From: Curtis, Jeffery S
To: [Russell, Merlin](#)
Cc: [Blandin, Norva](#); [Cinquino, Dawn](#)
Subject: RE: SK Medley questions
Date: Wednesday, September 27, 2017 5:49:36 PM

From: Russell, Merlin
Sent: Tuesday, September 26, 2017 7:56 AM
To: Curtis, Jeff <Jeff.Curtis@safety-kleen.com>
Subject: SK Medley questions

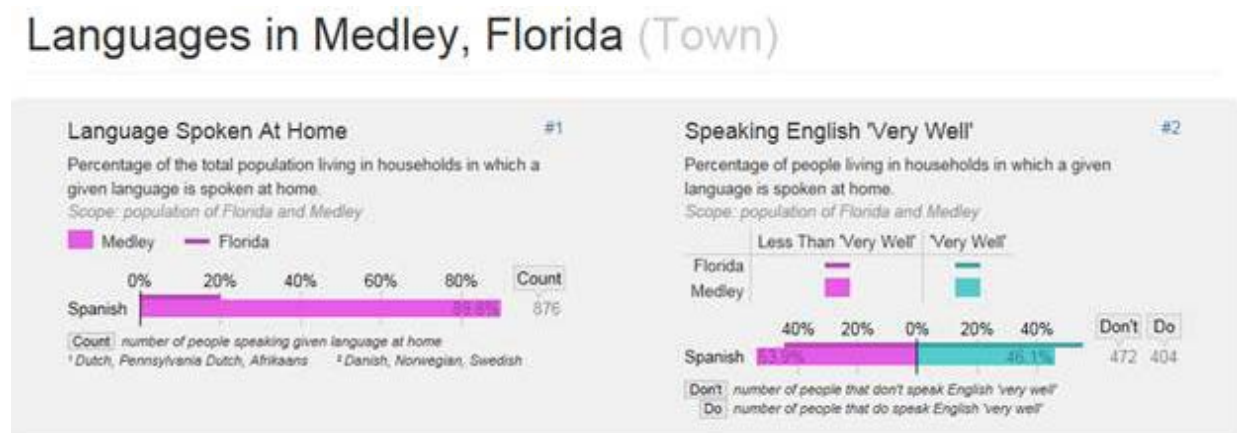
One question that came up was whether or not your warning signs were also in Spanish? Our district inspector indicated a high percentage of people in Medley that spoke Spanish. I did some googling on languages spoken in Miami-Dade County and found this:

I believe the warning signs are in both English/Spanish, but will confirm. If not, they will be ordered and posted in both. Yes, Medley has a high percentage of residents that speak Spanish first. This includes most of the employees at the branch.
